# PROPOSAL REQUEST

**PROJECT:** Williamson County Sheriff's Office Training Center  
8160 Chandler Road  
Hutto, TX 78634

**PROPOSAL REQUEST NO:** 17

**Description:** Monument Sign – Relocation & Modification

**MONUMENT SIGN**

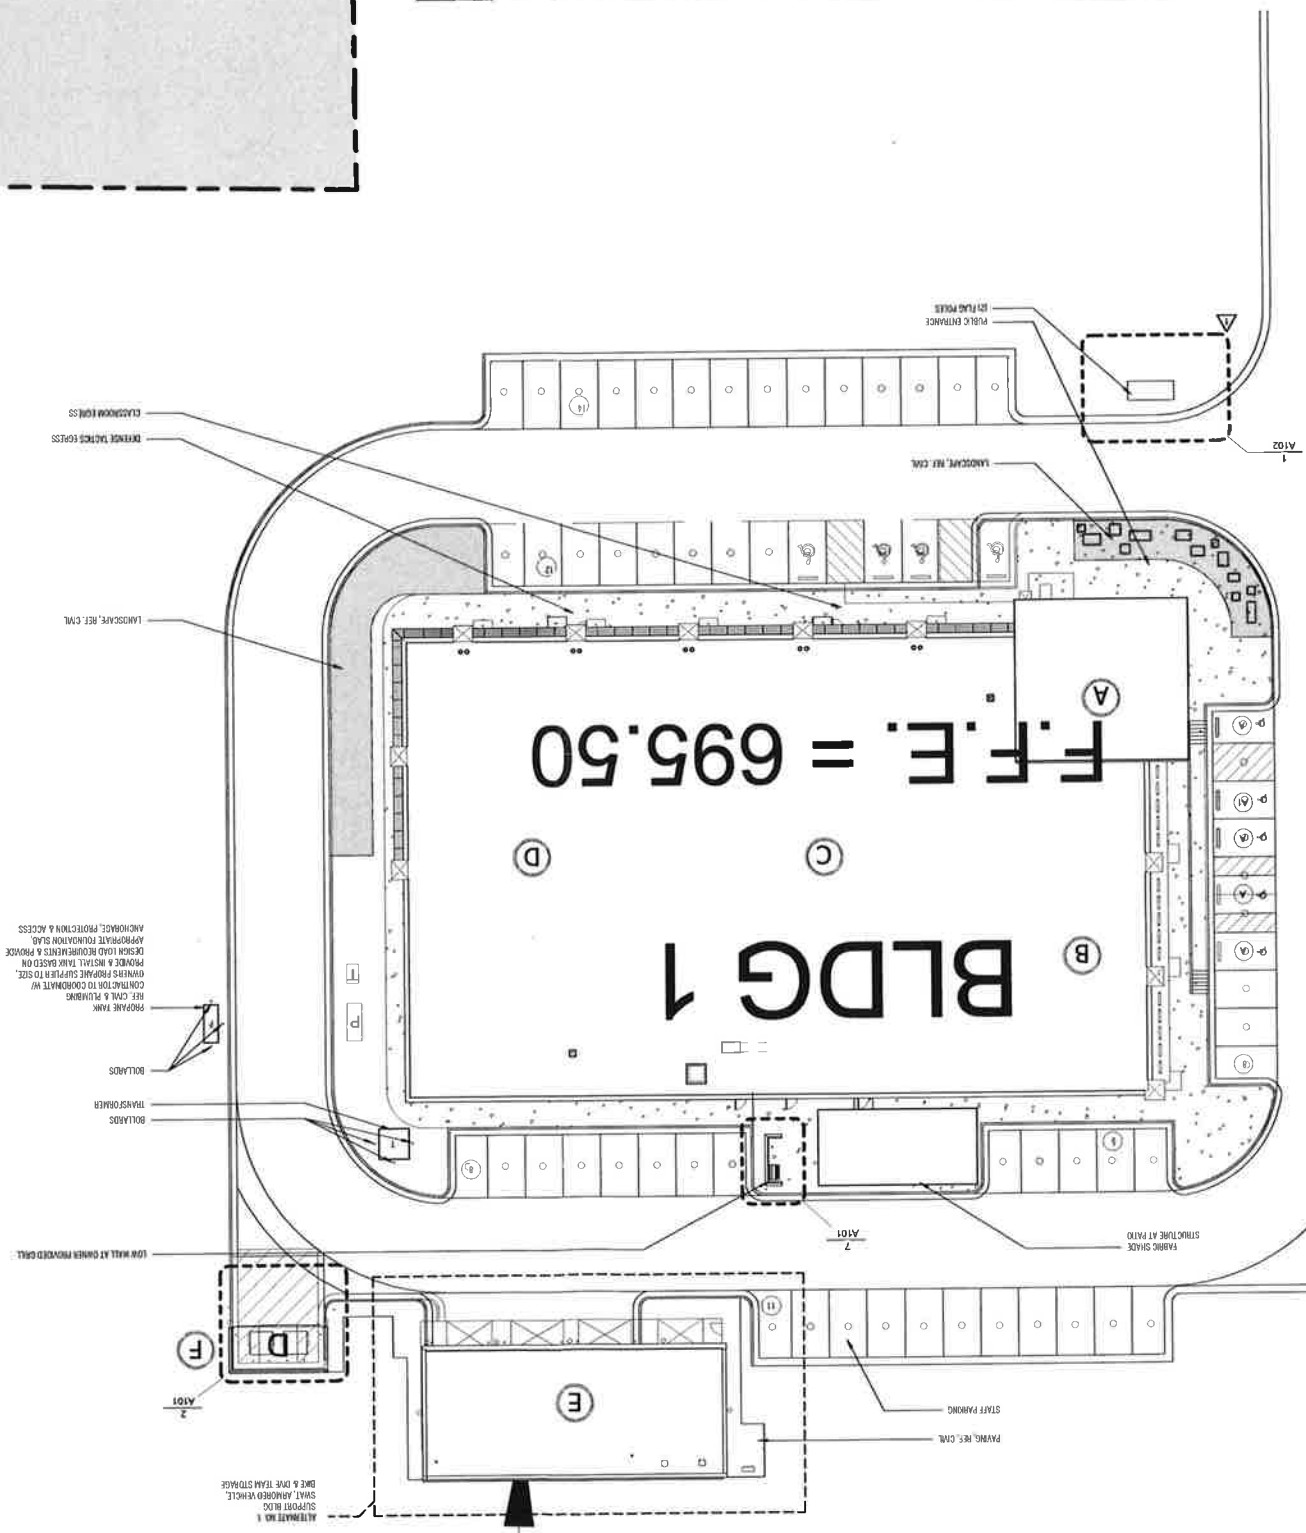
- Item No. 1. Sheet A100 – Site Plan  
A. Added detail 3  
B. Added callout to detail 3 on detail 2
- Item No. 2. Sheet A102 – Site Details  
A. Added monument sign details 2, 3, 4, 5, 6, 7, 8, & 9  
B. Refer to 11/S3.3, 4/S2.4 (P1), and S3.1 for Structural
- Item No. 3. Sheet E100 – Site Plan - Electrical  
A. Added power for monument sign lighting  
B. Added Type 'T8' and 'T9' fixtures to Fixture Schedule

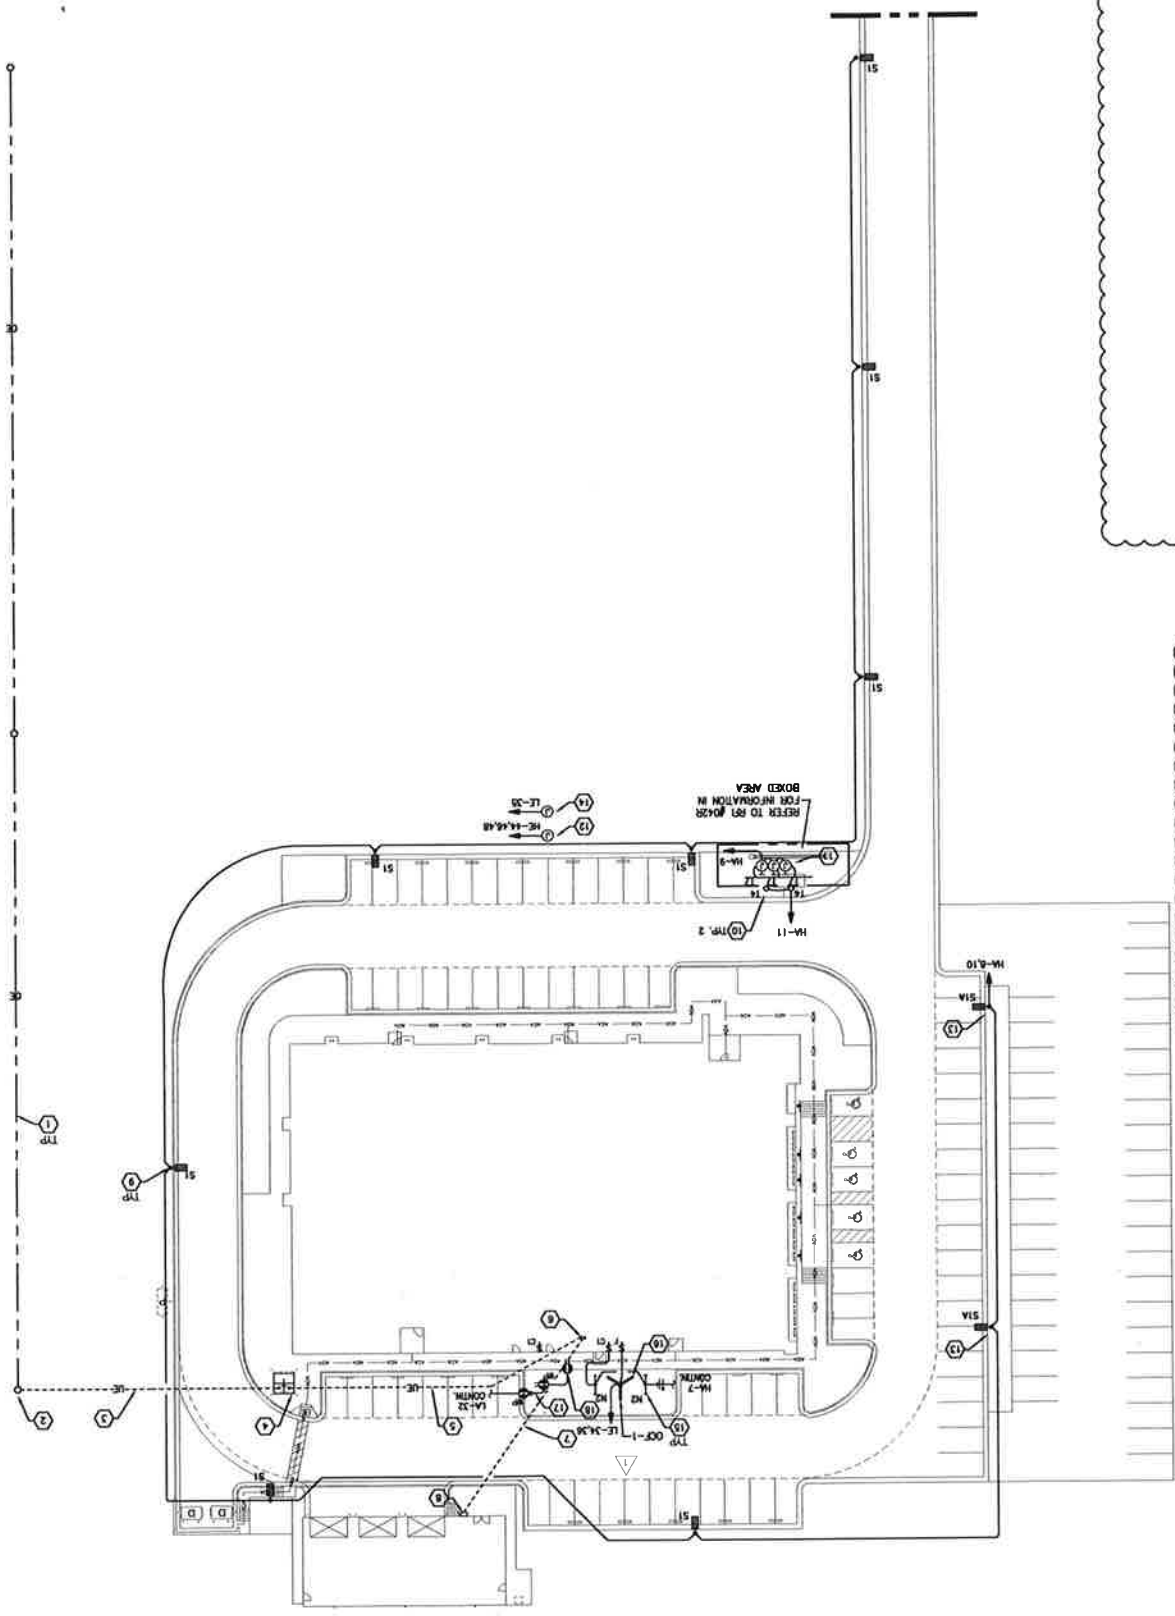
- 20 RECEPTACLE SURFACE MOUNTED TO SHADE STRUCTURE COLUMN.
  - 19 CONTRACTOR SHALL INTERCEPT EXISTING CONDUIT AND INSTALL A FLUSH IN-GRADE JUNCTION BOX FOR NEW CONDUIT TO SIGN. MONUMENT SIGN LOCATION ON AS BUILT DRAWINGS WITH DIMENSIONS FROM A FIXED OBJECT.

- 20 CONTRACTOR SHALL CONDUIT FROM NEW PULL BOX TO MONUMENT SIGN LOCATION. ROUTE 2 - #10 AND 1 - #10 GROUND IN A 3/4" CONDUIT.
  - 21 PROVIDE A NEMA 3R JUNCTION BOX ON THE END OF MONUMENT SIGN. COORDINATE EXACT LOCATION AND ALL REQUIREMENTS WITH ARCHITECT AND SIGN DETAILS.

- 22 COORDINATE MOUNTING OF LIGHTS FOR MONUMENT SIGN WITH ARCHITECTURAL DETAILS. FIELD COORDINATE PLACEMENT OF DRIVERS FOR LIGHTS BASED ON MAXIMUM LENGTH ALLOWED BY FIXTURES. THE HORIZONTAL TYPE TB SHALL BE 15' IN LENGTH WITH A DRIVER FOR EACH SIDE OF SIGN. THE VERTICAL TYPE TB SHALL BE 5' IN LENGTH WITH A DRIVER ON EACH END OF SIGN. COORDINATE ALL CONNECTION AND INSTALLATION REQUIREMENTS WITH FIXTURE MANUFACTURER.
